Washington State Modifications to the MUTCD*

M 24-01

Publications Transmittal

Errata notification to the May, 1996 Washington State Modifications to the **MUTCD**

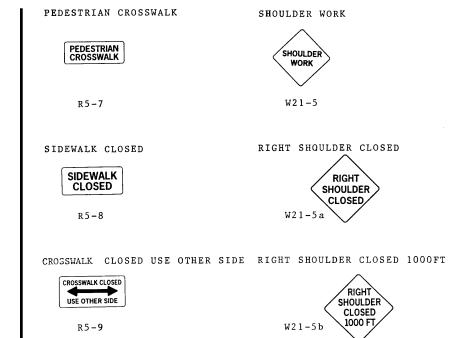
- 30. The word "optional" should be placed below the arrow displays on several pages. This agrees with the first sentence in section 6F-3.b. Listed below are the pages with the respective figure numbers:

```
On page 169, Figure TA-31; On page 171, Figure TA-32; On page 175, Figure TA-34; On page 181, Figure TA-37; On page 183, Figure TA-38; On page 185, Figure TA-39; On page 191, Figure TA-42; On page 195, Figure TA-44;
```
